SERVICE BULLETIN

Bulletin Number: SB1407
Date: 8/15/14

Product Affected: EC52FX730V3, EC52FX730V5, EC60FX730V3 & EC60FX801V5 mowers with serial numbers 61601 and below.

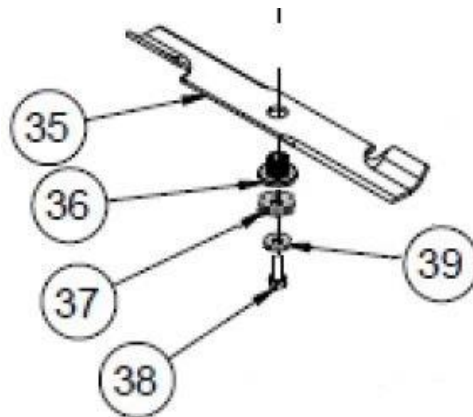
Situation: We had several customer requests to improve the durability of the spline driver 543085 used on the unit.

Solution: We worked with our supplier on the driver design and material composition. We also added a heavy flat washer as shown below.

Parts Required: In the future any orders for 543085 spline driver will be replaced with kit 542123 which contains the 543085 spline driver 103038 flat washer. The parts manuals will be updated as well.
